Access Compliance Report Public Rights-of-Way (Curb Ramps)

Main Street: RANDALL_ST Cross Street: N_STALLION_ST Location: NW

ADA ID: RPRK211222114315 Ramp Type: Type 4 - Parallel Initial Pass/Fail: Fail Overall Compliance: No Severity Score: 16

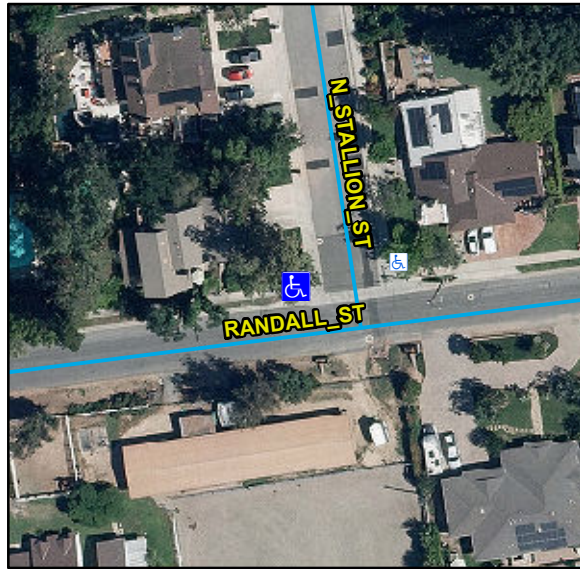
Compliance	Description	Data	Compliance	Description	Data
N/A	Ramp Length LT (in)	108	N/A	Ramp Length RT (in)	124
Yes	Ramp Width LT (in)	75	Yes	Ramp Width RT (in)	75
Yes	Ramp Run Slope LT (%)	4.4	No	Ramp Run Slope RT (%)	8.9
No	Ramp Cross Slope LT (%)	2.3	Yes	Ramp Cross Slope RT (%)	1.5
N/A	Landing Present	N/A	N/A	DWS Provided	N/A
N/A	Landing Length (in)	N/A	N/A	DWS Contrast	N/A
N/A	Landing Width (in)	N/A	N/A	DWS Length (in)	N/A
N/A	Landing Run Slope (%)	N/A	N/A	DWS Full Width	N/A
N/A	Landing Cross Slope (%)	N/A		DWS Offset Type	N/A
N/A	Landing Movement Obstructed?	N/A	N/A	DWS Offset Left (in)	N/A
	Landing Movement Type	N/A	N/A	DWS Offset Right (in)	N/A
N/A	Landing Shared	N/A			
N/A	Clear Space	Yes			
N/A	Clear Space To Crosswalk (in)	N/A			
N/A	Marked Crosswalk 1	No	N/A	Marked Crosswalk 2	No
	Crossing 1 Direction	S		Crossing 2 Direction	E
	Marked Crosswalk 1 Width (in)	N/A		Marked Crosswalk 2 Width (in)	N/A

Remove & Replace Curb Ramp With Two New Directional Ramps or Equivalent.

R304.5.3, R304.3.2, STD 1115
